# Groundwater Application Review Summary Form

Application # G- 19149

**SUBJECT: Scenic Waterway Interference Evaluation**

TO: Water Rights Section Date 02/01/2023  
 FROM: Groundwater Section Darrick E. Boschmann  
Reviewer's Name  
 SUBJECT: Application G- 19149 Supersedes review of 11/30/2021  
Date of Review(s)

**Stream-Depletion Model Results**

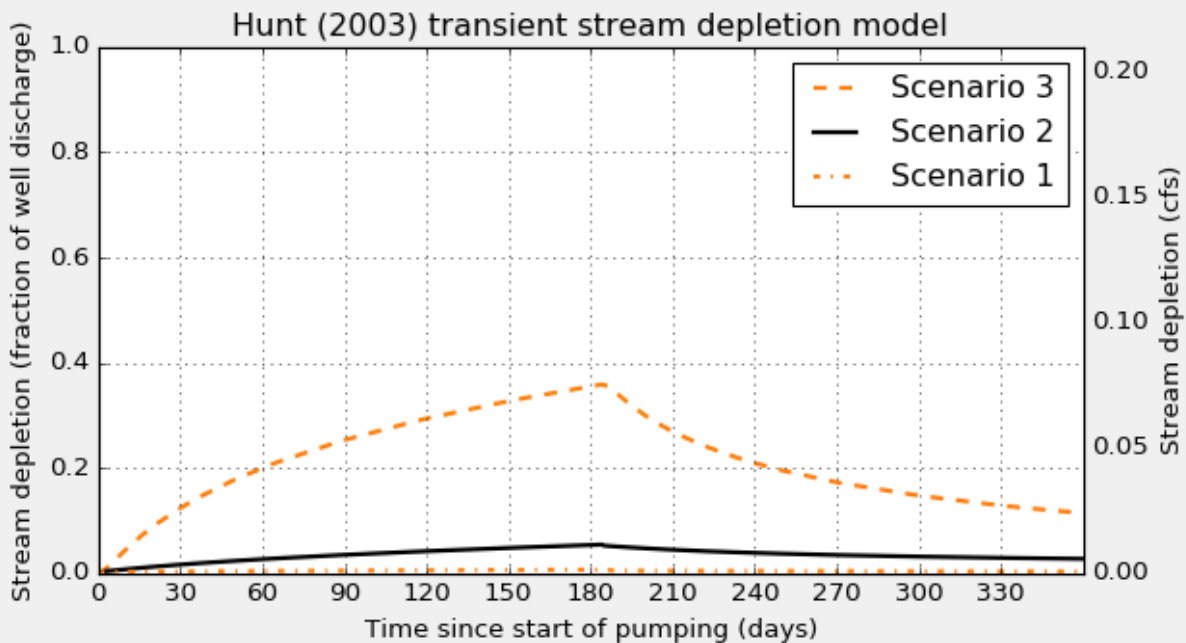
**Comments:** Stream-depletion was estimated using the Hunt-2003 stream-depletion model with parameter values within a range of values expected for the geology of the area and purposefully weighted toward values that would be more-likely to produce higher estimates of stream depletion in order to obtain a “worst-case” analysis.

**C6. SW / GW Remarks and Conditions:** The applicant's proposed POAs would be producing from an aquifer that has been found to be hydraulically-connected to surface water – specifically the Crooked River. The proposed rate is less than 1% of both the adopted natural streamflow and the instream right, and the estimated stream-depletion is less than 25% at 30 days, so the proposed use is not assumed to have the potential for substantial interference with surface water per OAR 690-009. However, the proposed POAs are hydraulically-connected to the Crooked River, which is upstream of the Deschutes State Scenic Waterway and will have a long-term impact on flows necessary for the scenic waterway. Given the distance between the POAs and the Crooked River, and the river-distance between the Crooked River near the POAs and the Deschutes State Scenic Waterway, along with the reservoirs in between, the impact from the proposed use on the scenic waterway will likely be evenly distributed throughout the entire year.
